Re: Addendum No. 1

Bellflower/Meadowbrook Ditch Restoration Project

City of Mentor

Date: January 3, 2025

SHEET NAME SCM-1 20

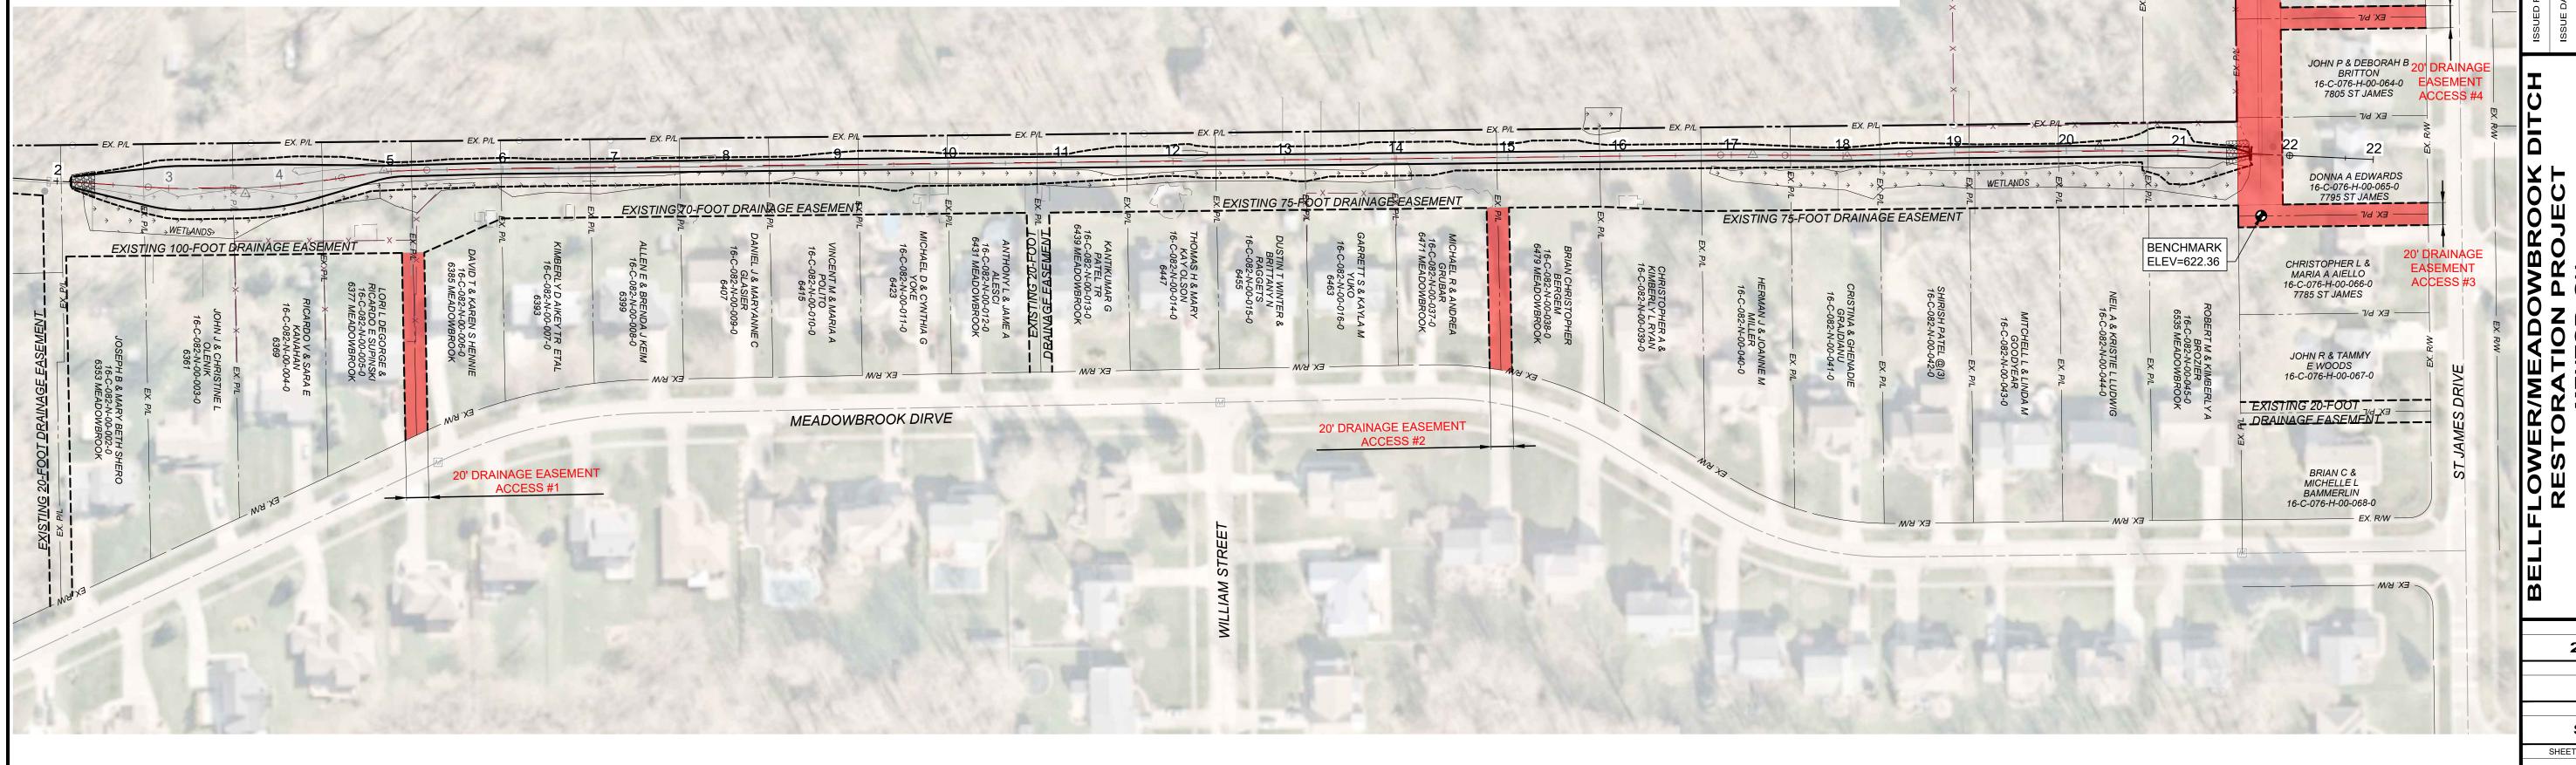
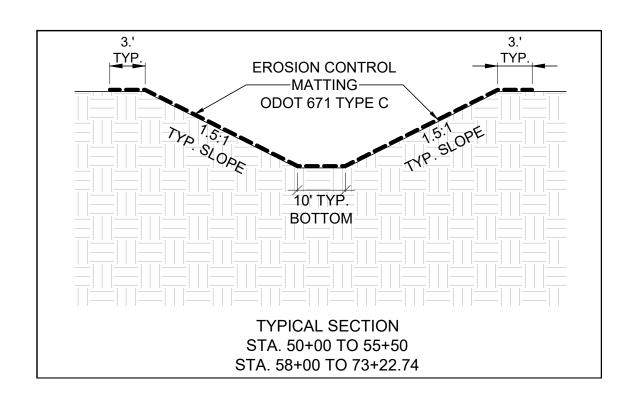
Replace plan sheets 4 and 5 with the enclosed Revised plan sheets 4 and 5.

Yes, Easement Access #11 has been added to sheet 4. Additional fence quantity has been added to bid-form.

- 1) THE FOLLOWING EASEMENT ACCESS LOCATIONS ARE AVAILABLE FOR USE: - ACCESS #1: BETWEEN 6377 & 6385 MEADOWBROOK DR FENCE ALONG PROPERTY LINE. TO BE REMOVED DURING CONSTRUCTION AND RECONSTRUCTED TO ORIGINAL QUALITY.
- ACCESS #2 BETWEEN 6471 & 6479 MEADOWBROOK DR - ACCESS #3 BETWEEN 7785 & 7795 ST JAMES DR
- ACCESS #4 BETWEEN 7804 & 7814 ST JAMES DR
- 2) THE FOLLOWING EASEMENT ACCESS LOCATIONS SHALL NOT BE USED: - 20' DRAINAGE EASEMENT BETWEEN 6345 & 6353 MEADOWBROOK DR DUE TO MANY LARGE TREES AND LANDSCAPING
- 20' DRAINAGE EASEMENT BETWEEN 6431 & 6439 MEADOWBROOK DR DUE TO SMALL OPENING BETWEEN MANY LARGE TREES
- 40' DRAINAGE EASEMENT BETWEEN 7835 ST JAMES & 6530 SYCAMORE DUE TO WOOD AND CHAIN LINK FENCE BLOCKING ACCESS

1) ALL TREES GREATER THAN 3 INCHES DIAMETER BREAST HEIGHT MUST BE CUT DOWN BY MARCH 15, 2025.

# 2) CLEARING LIMITS = DITCH GRADING LIMITS.

- 1) CONTRACTOR MAY DRIVE IN AND THROUGH DITCH AND WETLANDS.
- 2) CONTRACTOR SHALL NOT STORE FILL OR PLACE CONCRETE IN WETLANDS. 3) CONTRACTOR SHALL RESTORE WETLANDS TO PREVIOUS CONDITION WITH WETLAND SEED MIX.
